UNITED STATES PATENT AND TRADEMARK OFFICE

APPLICATION NO.	FILING DATE	FIRST NAMED INVENTOR	ATTORNEY DOCKET NO.	CONFIRMATION NO.
09/873,144	06/01/2001	Erik K. Jurvis	25039A	3286

# Office Action Summary

## DETAILED ACTION

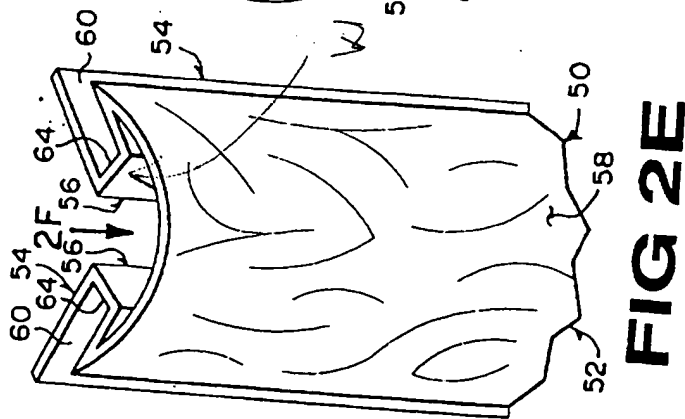
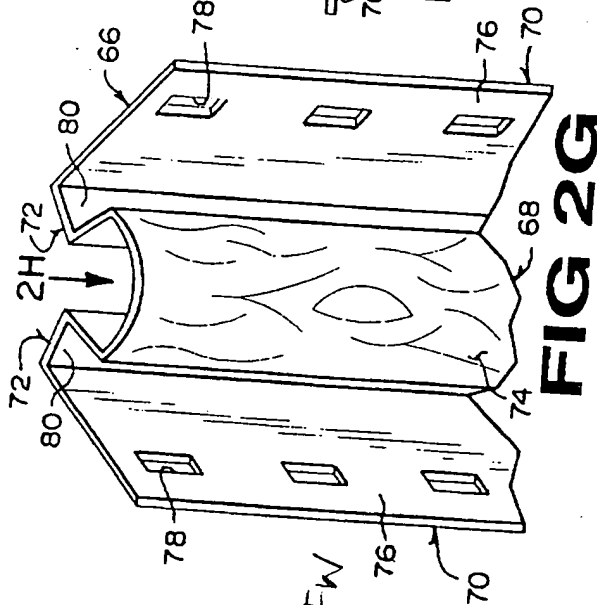
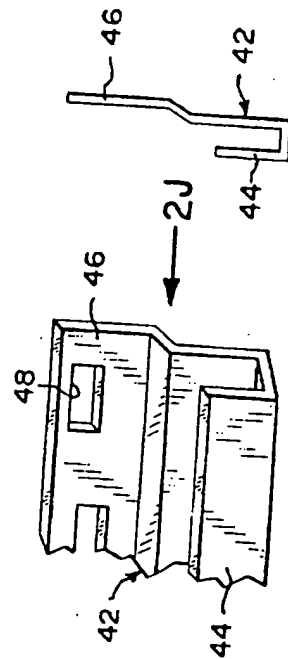
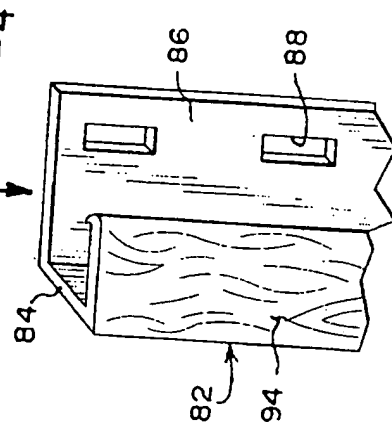
3. Claims 1,6 and 7 are rejected under 35 U.S.C. 102(b) as being anticipated by US Patent #5,090,174 to FRAGALE. FRAGALE discloses a component for receiving a plurality of siding members (30) for covering the wall including an elongated body (10) having first and second receivers (28) on opposing sides of the body (10). The component includes a first wall (11) and an end wall (W), see the marked-up attachment wherein the endwalls (E) are parallel.
